Access Compliance Report

(Curb Ramps)

Intersection ID: 52906	Main Street: JOHNSTON_RD	Cross Street: CLEMS_CROSSING_DR	Location: SE
ADA ID: CC236D25C25E	Ramp Type: BlendTrans1	Initial Pass/Fail: Fail	Overall Compliance: No
Severity Score: 1.25			
Codes/Mitigation Info/Possible Solution		Field Measurements/Component Compliance

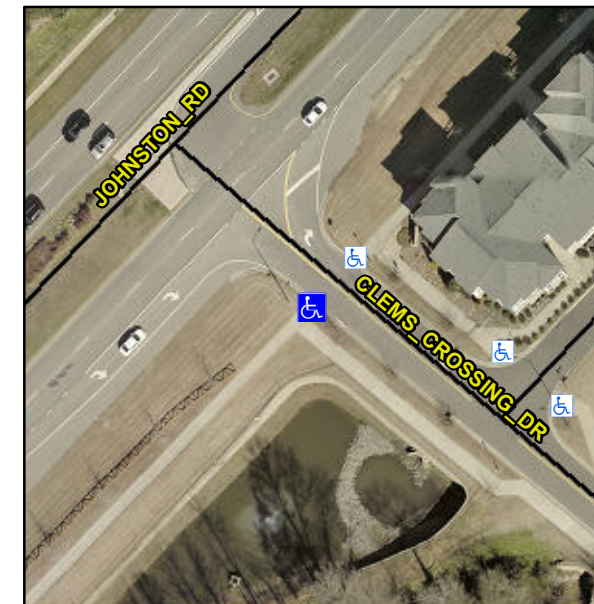
Not Found, R304.5.3

Compliance	Description	Data	Compliance	Description	Data
N/A	Ramp Length (in)	72.0	Yes	BlendTrans Slope (%)	1.1
Yes	Ramp Width (in)	71.0	No	BlendTrans XSlope (%)	2.2
N/A	Flare Type LT	N/A	N/A	Flare Type RT	N/A
N/A	Flare Slope LT (%)	N/A	N/A	Flare Slope RT (%)	N/A
N/A	Flare Traversable LT?	N/A	N/A	Flare Traversable RT?	N/A
N/A	Landing Length (in)	N/A	N/A	DWS Provided?	N/A
N/A	Landing Width (in)	N/A	N/A	DWS Contrast?	N/A
N/A	Landing Slope (%)	N/A	N/A	DWS Length (in)	N/A
N/A	Landing X Slope (%)	N/A	N/A	DWS Full Width?	N/A
N/A	Landing Curb? (Y/N)	N/A	N/A	DWS Offset (in)	N/A
N/A	Shared Landing?	N/A			
N/A	Gutter Ponding?	N/A	N/A	Gutter Slope (%)	N/A
N/A	Gutter Lip Ht (in)	N/A	N/A	Gutter X Slope (%)	N/A
N/A	Painted X Walk1?	No	N/A	Painted X Walk2?	N/A
	X Walk 1 Direction	To NE		X Walk 2 Direction	N/A
	X Walk 1 Width (in)	N/A		X Walk 2 Width (in)	N/A
	X Walk 1 Slope (%)	0.1		X Walk 2 Slope (%)	N/A
	X Walk 1 X Slope (%)	1.4		X Walk 2 X Slope (%)	N/A

N/A	Ramp inside XWalk1?	N/A	N/A	Ramp inside XWalk2?	N/A
	Road Slope (%)	1.4		Clear Space?	N/A
	Road X Slope (%)	0.1	N/A	Clear Space to XWalk (in)	N/A
N/A	Any Obstructions?	N/A	N/A	Storm Grate/Utility Hazard?	N/A
	Obstruction Type			Storm Grate/Utility Type	
		N/A			N/A
			Yes	Surface Condition? (G/P)	Good
			No	Curb Slope (%)	12.6

Remove & Replace Curb Ramp With Two New Directional Ramps or Equivalent.
